RE: 2014Re-mining Scofield Waste, Clean Copies, Canyon Fuel Company, LLC, Skyline Mine,
C/007/005, Task ID 4590

Title: 2014 Waste Rock Remining – Clean copies Task ID 4590

Modified Plates 3.2.8-1 and 3.2.8-2 , pages 3.56, 4-39a1 to include topsoil and subsoil storage areas

WASTE ROCK FACILITIES JUN 10 2014

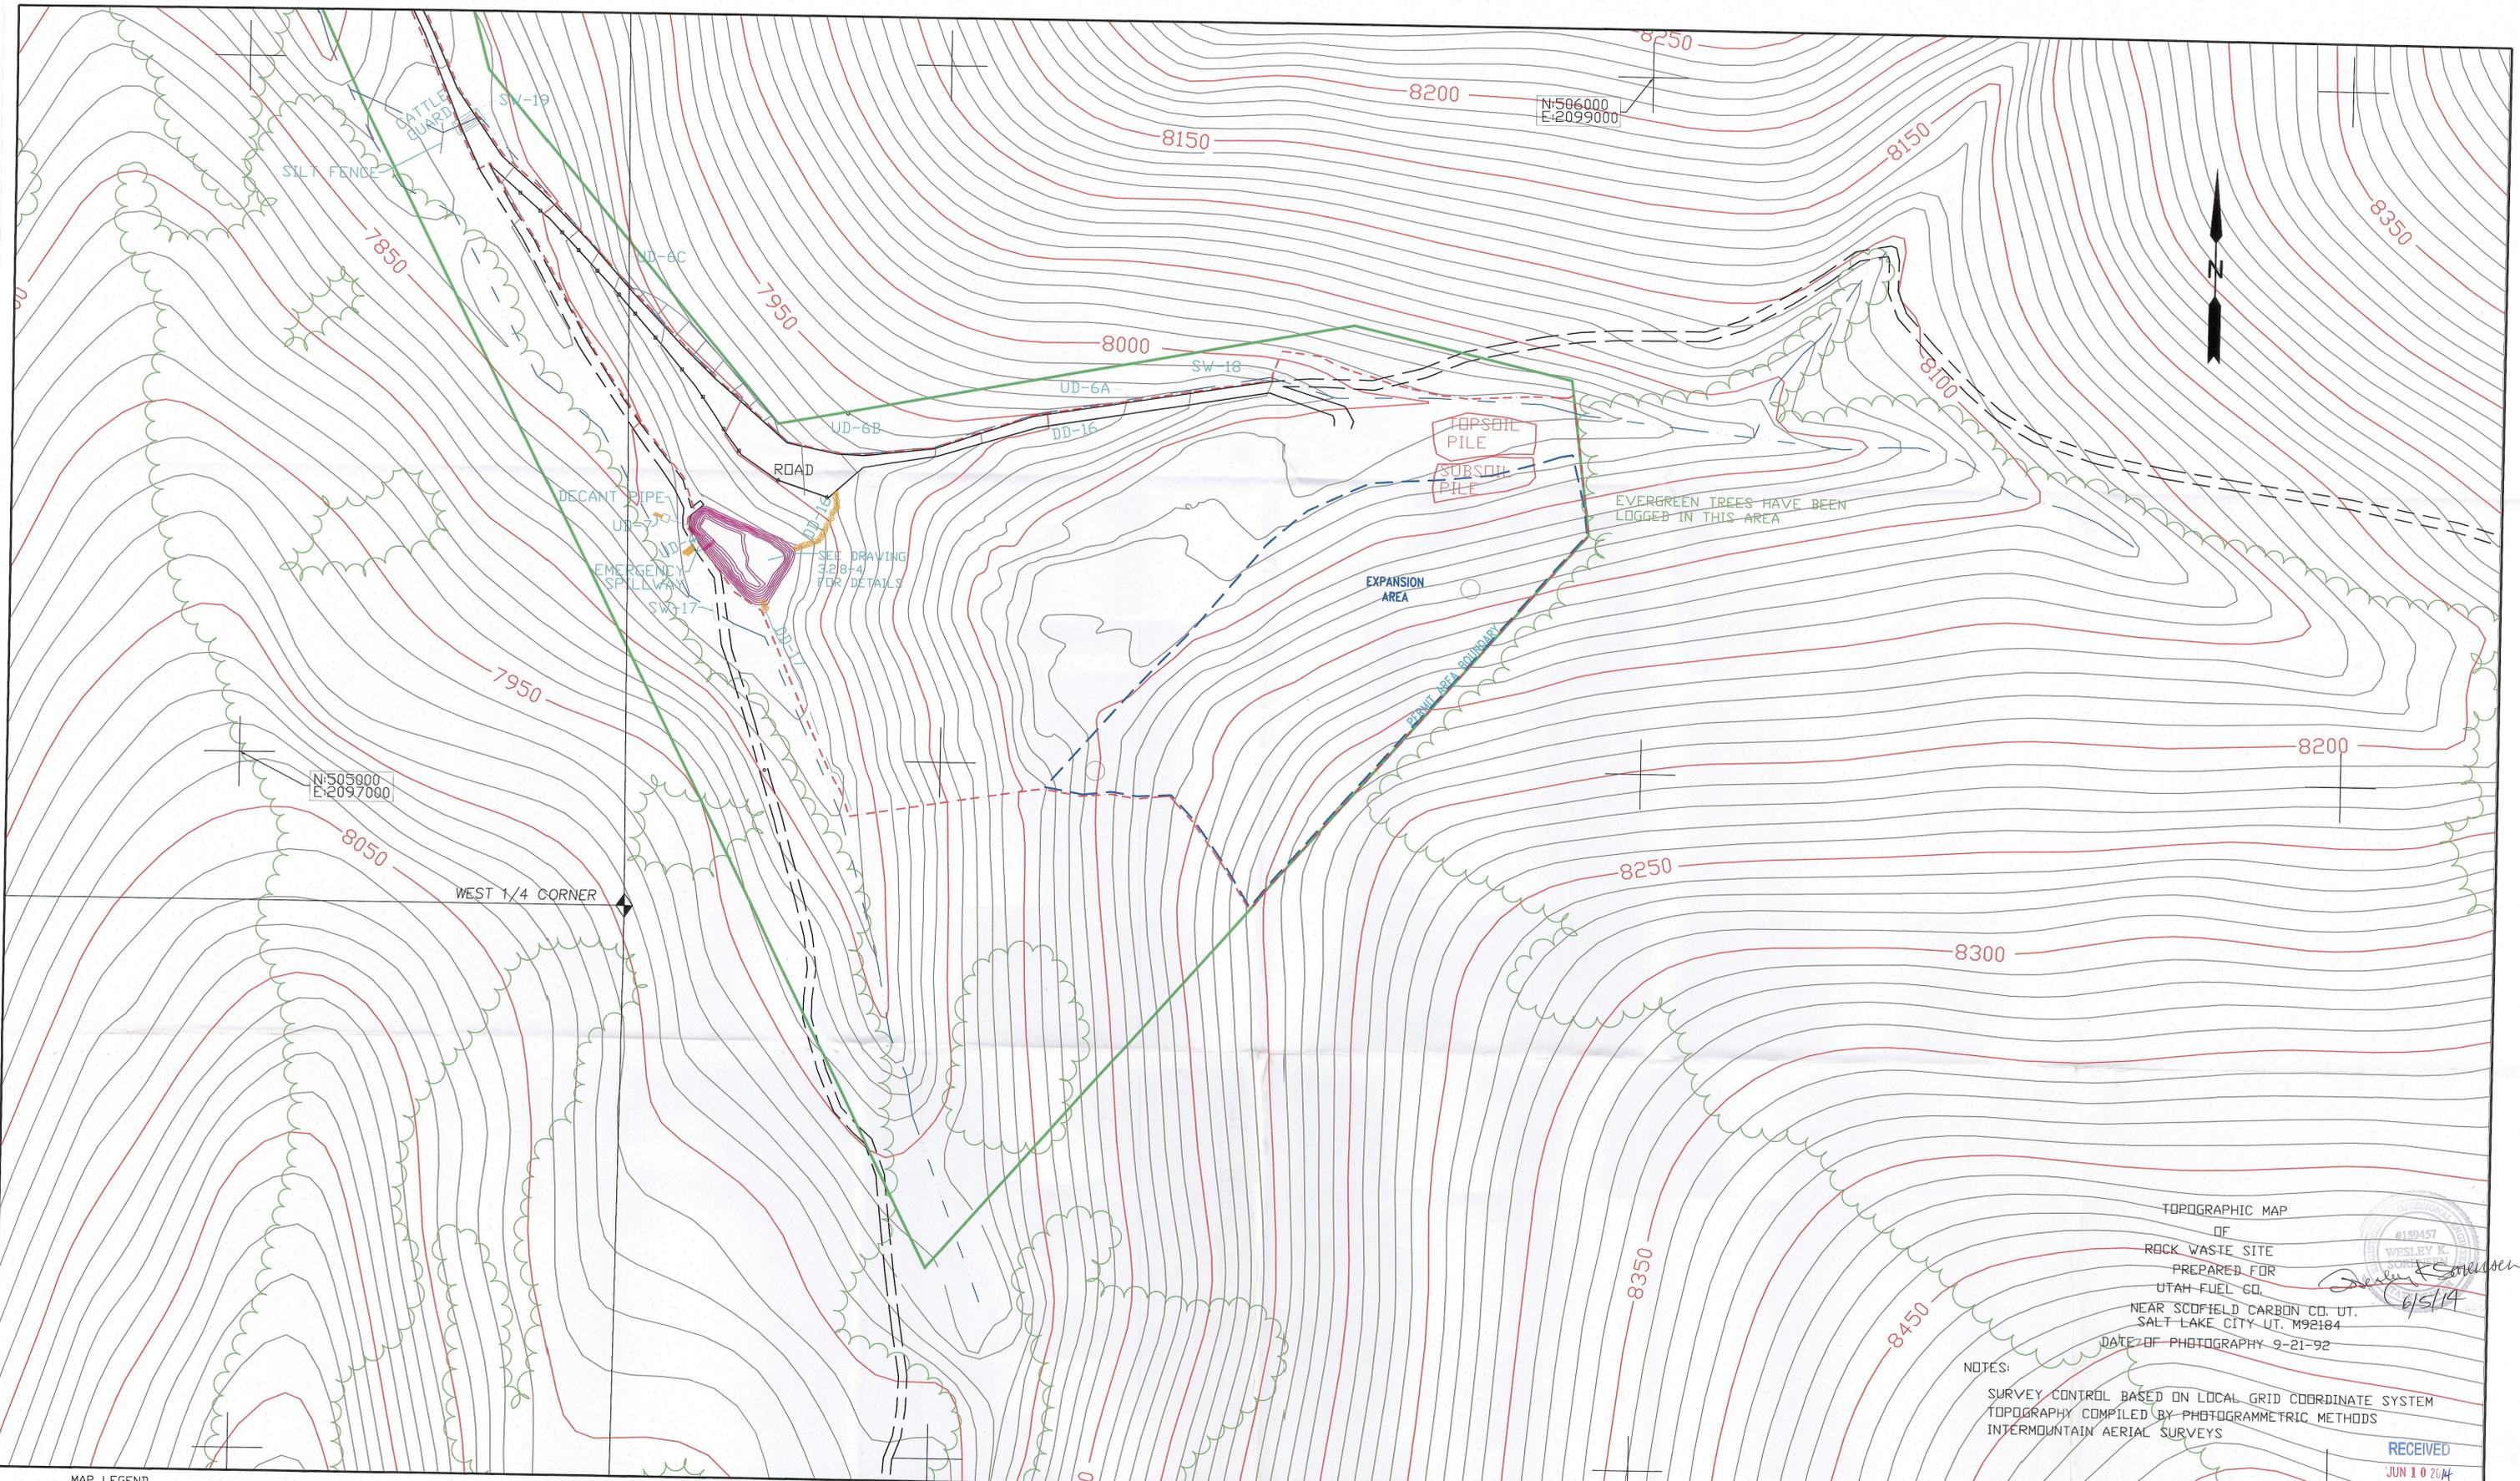
DATE	No.	REVISIONS	APP/CHK	DES/DR
7-89	1	ADD AREA 24-A		
9-20-89	2	DITCH NUMBER'S CHANGED		
9-29-89	3	NOTE ADDED		
7-1-92	4	REVISED FOR PIT EXPANSION		
5-19-94	5	ADD AREA 24-A		
5-02-07	6	ADDED EXPANDED PERMIT AND DISTURBED AREA, AS-BUILT SEDIMENT POND, AND UNIMPROVED ROAD	G.G./R	
5-15-14	7	ADDED Topsoil/Subsoil Piles, Removed "Access Road" from title block	G.G./G.G.

DATE	No.	REVISIONS	APP'D	CHK'D
09-1-98	1	SHOW EXPANDED AREA	/	G.T./F.F.
11-10-98	2	ADDED TOP SOIL STOCKPILE	/	G.T./F.F.
01-11-98	3	SHOW ALL OF PERMIT AREA BOUNDARY	/	G.T./F.F.
04-16-99	4	TEMPORARY DRAINAGE DIVERSION	/	G.T./F.F.
10-12-05	5	REMOVED SILT FENCE ALONG ACCESS ROAD	/	G.G./A.T.
02-01-06	6	REMOVE ROAD LINES, FIX TITLE BLOCK	/	G.G./A.T.
05-02-07	7	ADDED EXPANDED PERMIT, DISTURBED, AND PILE EXPANSION AREA, AS-BUILT SEDIMENT POND, AND UNIMPROVED ROAD.	/	G.G./B.R.
05-09-08	8	ADDED TOPSOIL PILE, MODIFIED EXPANSION AREA LINE	/	G.G./B.R.
05-15-14	9	Relocated one topsoil pile, ADDED subsoil pile	/	G.G./G.G.
